INDEPENDENT ORBITER ASSESSMENT

**FMEA/CIL
ASSESSMENT
INTERIM REPORT**

9 MARCH 1988

WORKING PAPER NO. 1.0-WP-VA88003-40

Figure C.26a - OMS HARDWARE ASSESSMENT

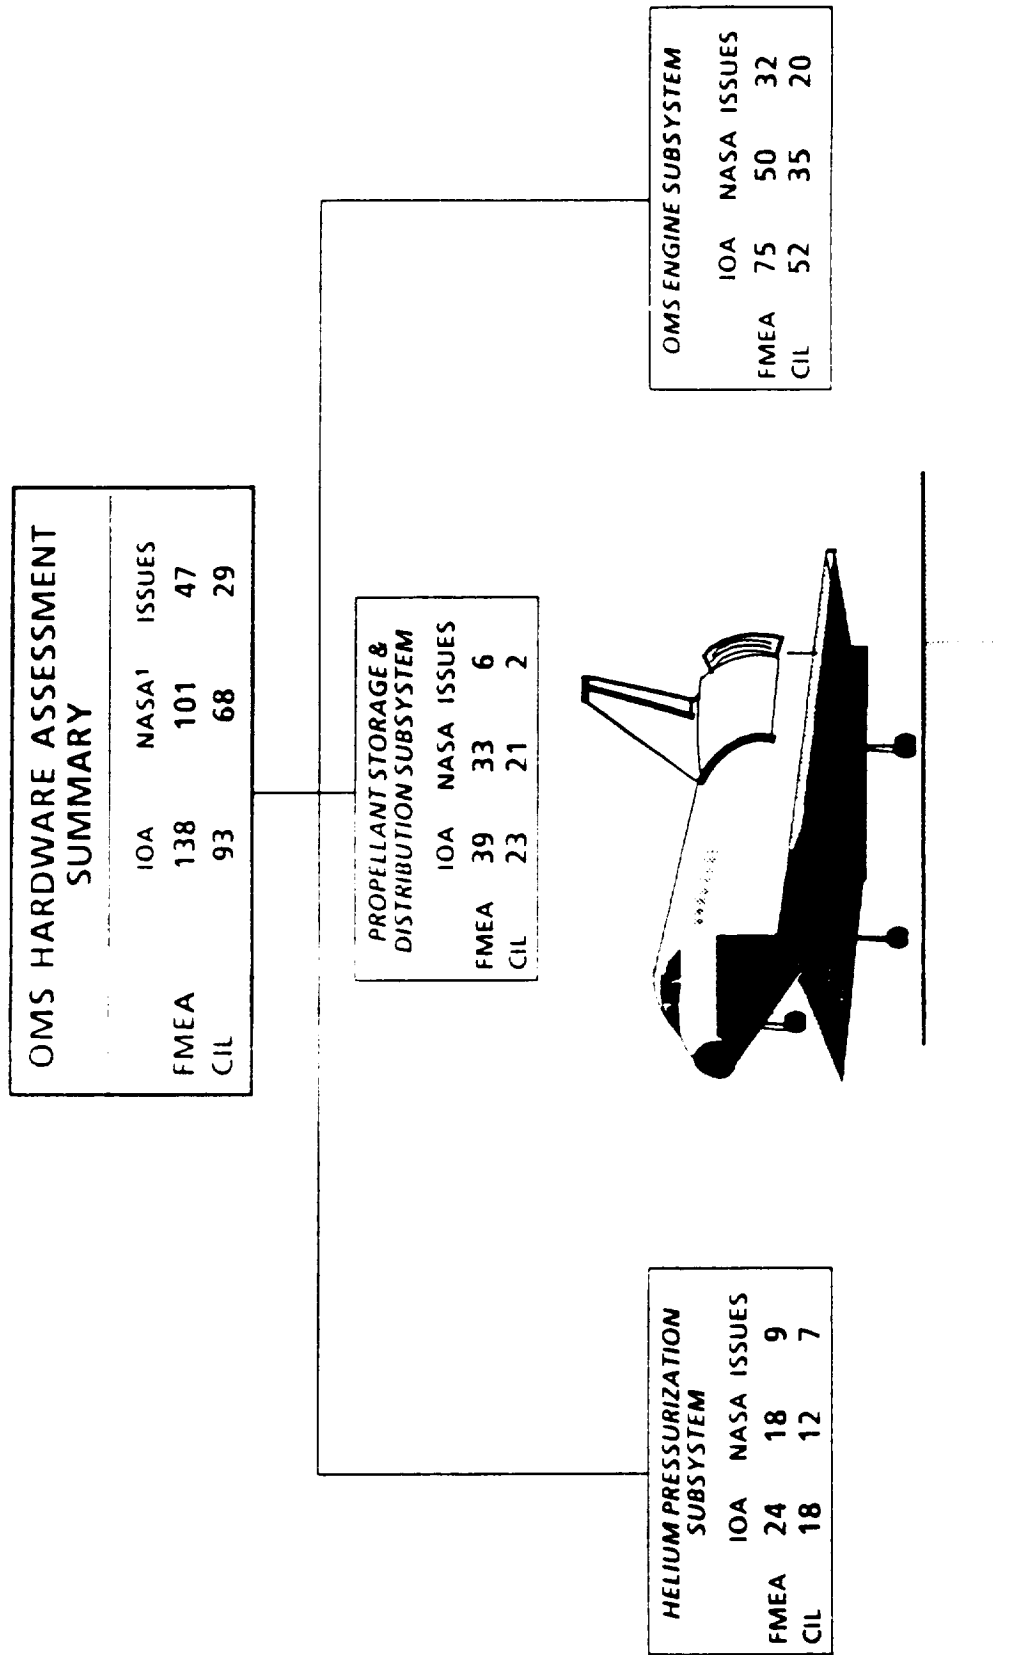
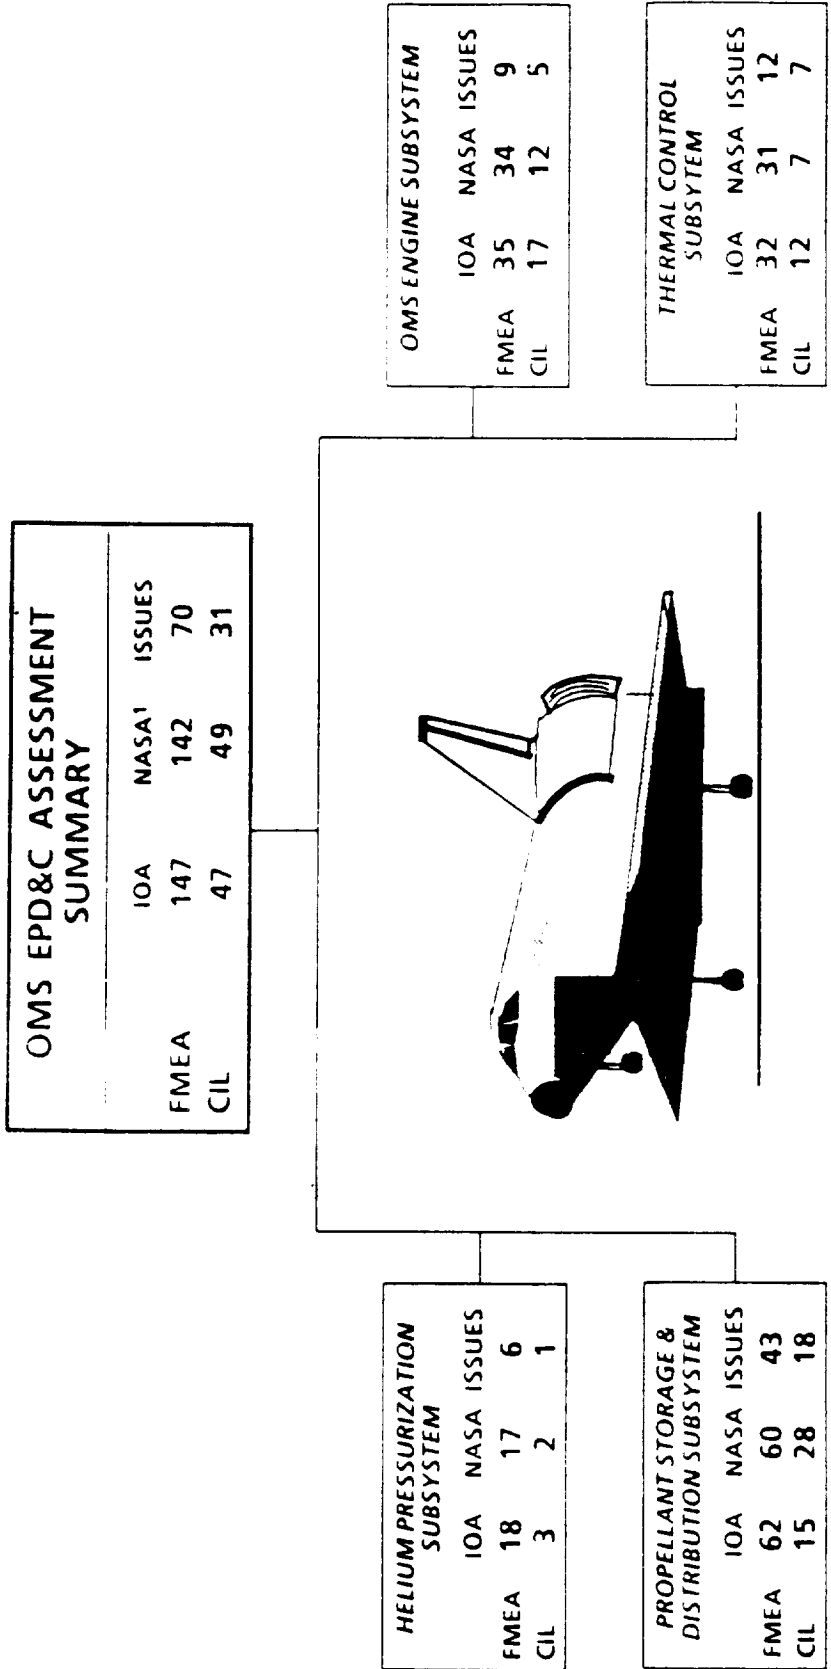
A number of the unresolved hardware and EPD&C issues involve failure modes identified by IOA which are not currently addressed on the NASA FMEA/CIL baseline. IOA considers each of these failure modes to be credible, and recommends that they be added.

The remaining unresolved OMS hardware and EPD&C issues result because of differences between the IOA and NASA/RI analyses of the OMS subsystem, which resulted in criticality, redundancy screen, or failure effect differences.
